Access Compliance Report

Public Rights-of-Way

(Curb Ramps)

Intersection ID: 43114	Main Street: HAMORTON_PL	Cross Street: THE_PLAZA	Location: NE
ADA ID: 9E1BE23812E8	Ramp Type: Directional1	Initial Pass/Fail: Pass	Overall Compliance: No
Severity Score: 0			
Codes/Mitigation Info/Possible Solution		Field Measurements/Component Compliance

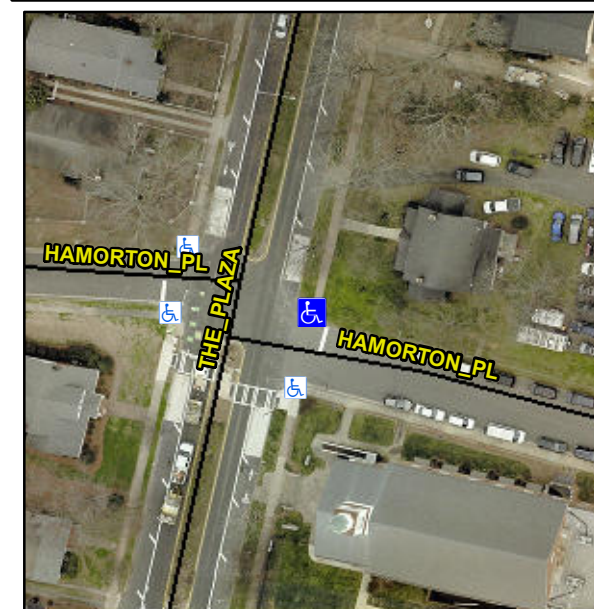
NO CURB

**R304.2.2-Perp, R304.3.2-Para,
R304.5.3, R305.2, R302.7**

Compliance	Description	Data	Compliance	Description	Data
N/A	Ramp Length (in)	70.0	Yes	Grade Break?	Yes
Yes	Ramp Width (in)	51.0	No	Grade Break Slope (%)	6.0
Yes	Ramp Slope (%)	5.7	Yes	Grade Break XSlope (%)	1.1
Yes	Ramp XSlope (%)	1.7			
N/A	Flare Type LT	N/A	N/A	Flare Type RT	N/A
N/A	Flare Slope LT (%)	N/A	N/A	Flare Slope RT (%)	N/A
N/A	Flare Traversable LT?	N/A	N/A	Flare Traversable RT?	N/A
Yes	Landing Length (in)	62.0	Yes	DWS Provided?	Yes
Yes	Landing Width (in)	52.0	Yes	DWS Contrast?	Yes
No	Landing Slope (%)	7.0	Yes	DWS Length (in)	24.0
Yes	Landing X Slope (%)	1.5	Yes	DWS Full Width?	Yes
N/A	Landing Curb? (Y/N)	N/A	No	DWS Offset LT (in)	5.5
N/A	Shared Landing?	No	Yes	DWS Offset RT (in)	6.5
No	Gutter Ponding?	Yes	Yes	Gutter Slope (%)	4.5
Yes	Gutter Lip Ht (in)	0.0	No	Gutter X Slope (%)	2.1
N/A	Painted X Walk1?	No		Road Slope (%)	1.5
	X Walk 1 Direction	To S		Road X Slope (%)	3.3
	X Walk 1 Width (in)	N/A		Clear Space?	Yes

Remove & Replace Entire Ramp.
Remove & Replace Gutter.
